Dear Members of Council and Planning Commission,

As Lee St. neighbors of the Park Avenue T-Zones, we have followed closely the proposed rezoning of the nearby properties. We do appreciate the fact that the Council chose to review this zoning. We laud the stated goal of encouraging more housing, particularly more affordable dwellings. We also believe that it is vital to maintain Park Avenue as a pedestrian and bike friendly street so that Falls Church residents can enjoy many fun runs and parades under the shade of street trees for years to come.

Park Avenue T-Zone Lots Fully Built

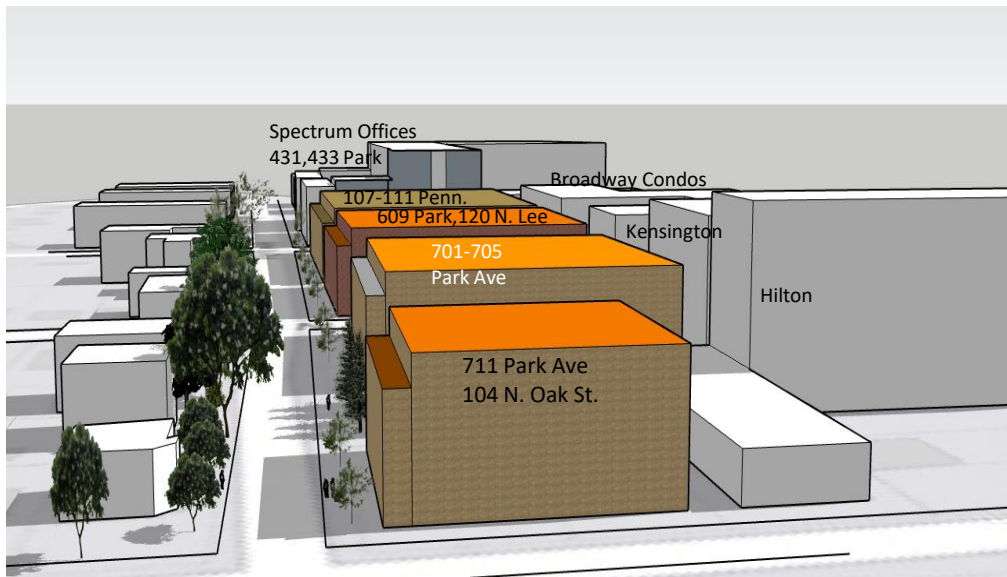
Rendition of Park Avenue with four fully built T-Zone lots between Oak St and Pennsylvania Ave with proposed dimensions of 20 ft. front setbacks, 50 ft. heights with 10 ft. setbacks at 40 ft. in front. This section of Park Avenue is about 40 ft. wide. Shadows as seen on March 21st, 2 p.m.

Underground infrastructure affects where trees can be planted.

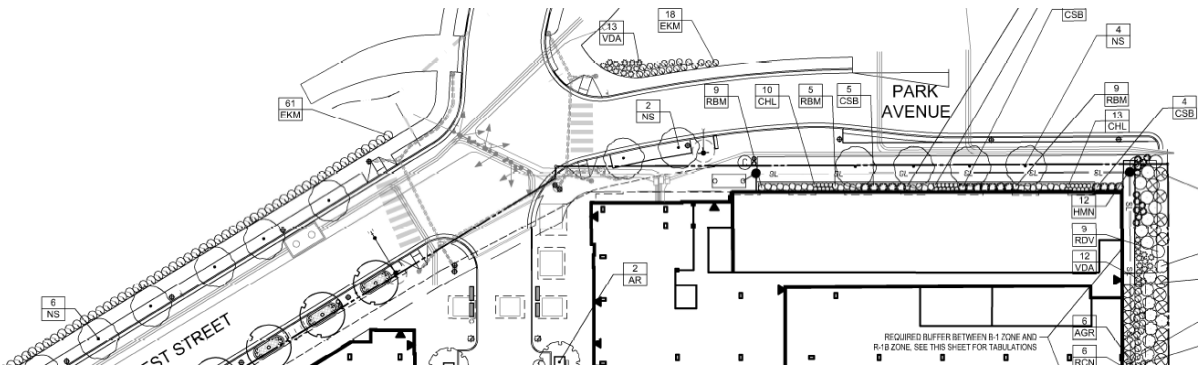
Diagram above is extracted from the Founders Row landscape drawing. It shows sewer lines, electrical lines run along Park, about 2 ft. from the street curb. (Shown as grey lines.) This means that trees have to be planted at least 7 ft. from the curb. These utilities run down the length of Park.

At Founders Row, the setback is at least 24 ft. The trees are planted 10 ft. from the building (14 ft. from the curb) and receive about 4 hours of direct light at the summer solstice, when the sun is at its highest during the year. This is because the trees are on the North side of all buildings on the T-Zone side of Park.

Shadows made by a 40-50 ft. building on Park Avenue.

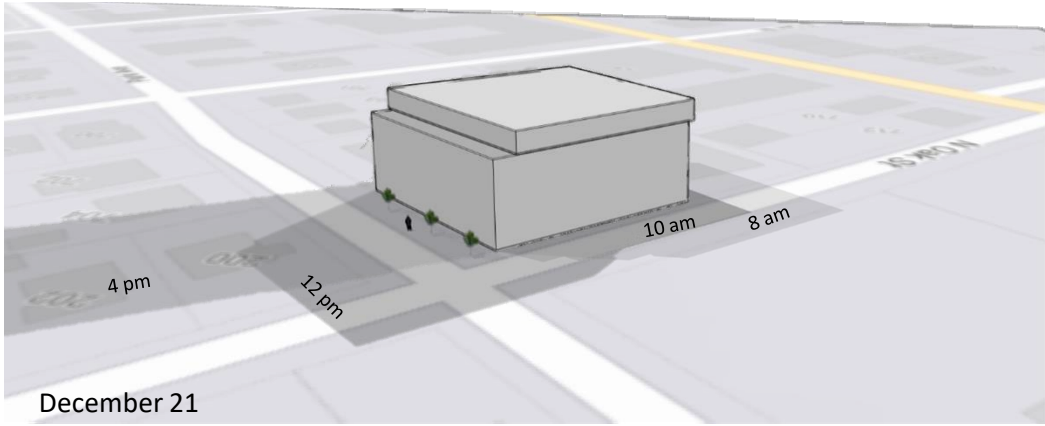
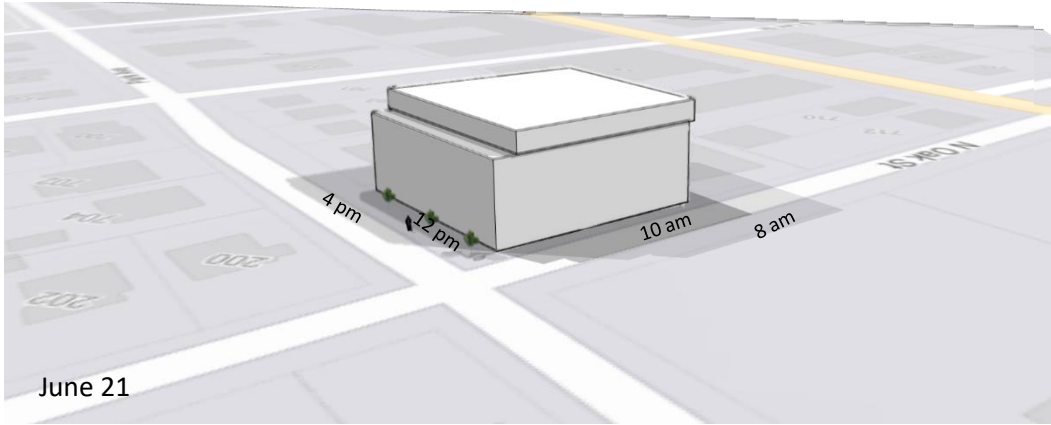
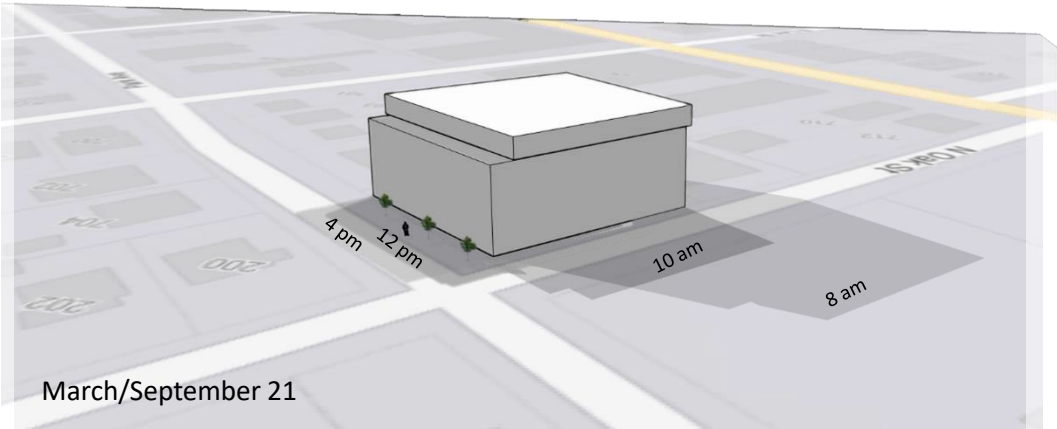
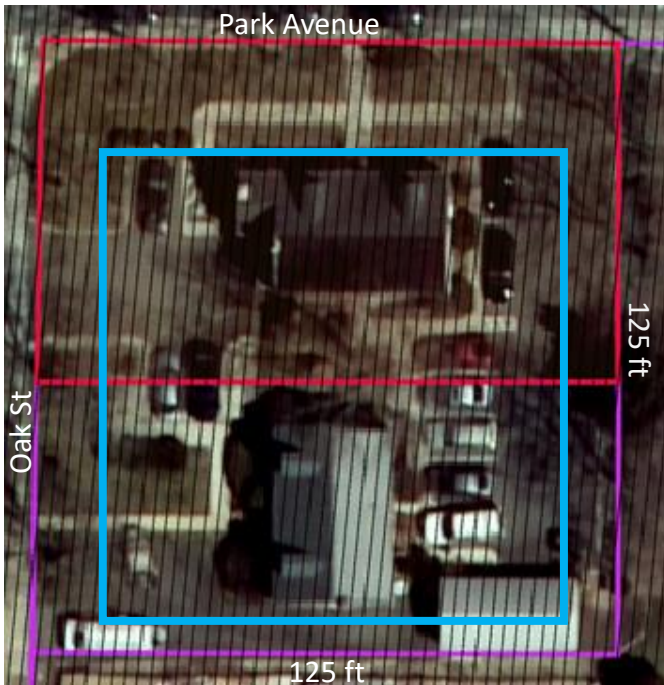
The shadows for the 2 solstices and 2 equinoxes are shown using the Park/N. Oak location as reference. Trees placed 10 ft. from the building will get at most 4 hours of light for 3 months around June 21st.

711 Park, 104 N. Oak

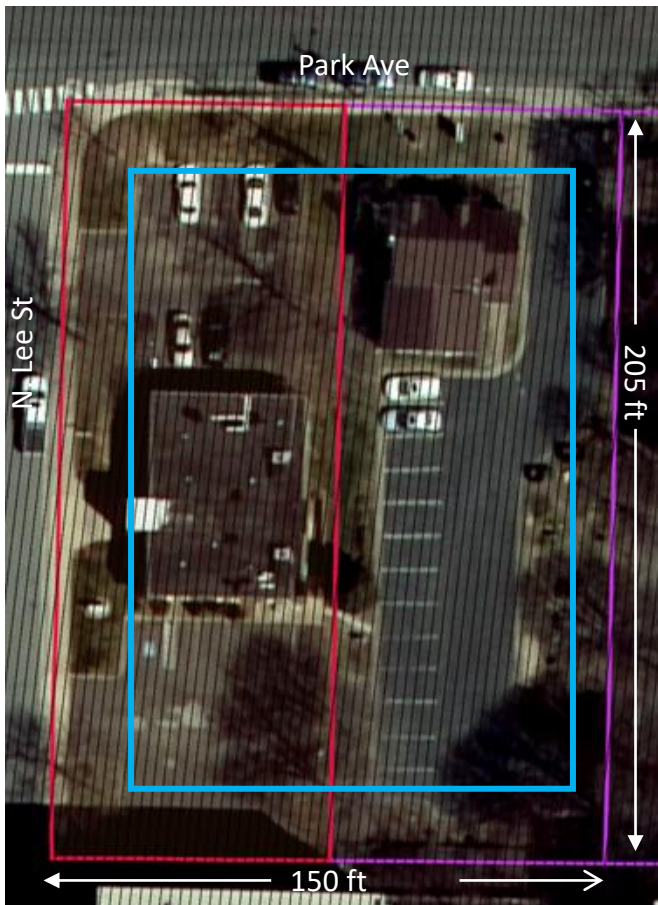
20 ft. front setback on Park Ave
15 ft. setback on Oak, 10 ft. rear, sides
Buildable area (in blue) = 95 ft. x 100 ft.
= 9,500 sq ft.
or 61% of lot

15 ft. front setback on Park Ave
15 ft. setback on Oak, 10 ft. rear, sides
Buildable area = 100 ft. x 100 ft.
= 10,000 sq ft.
or 64% of lot

609 Park Ave, 120 N Lee

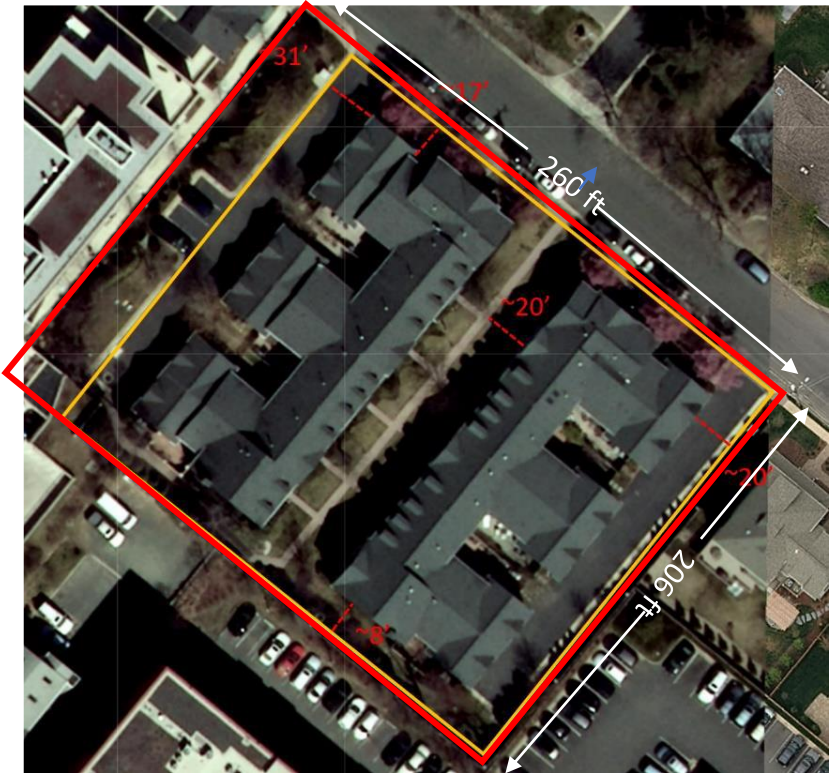
20 ft. front setback on Park Ave
15 ft. setback on Lee, 10 ft. side
20 ft. rear setback
Buildable area (in blue) = 125 ft. x 165 ft.
= 20,625 sq ft.
or 69% of lot

20 ft. front setback on Park Ave
15 ft. on Lee
10 ft. rear and side
Buildable area = 125 ft. x 175 ft.
= 21,875 sq ft.
or 73% of lot
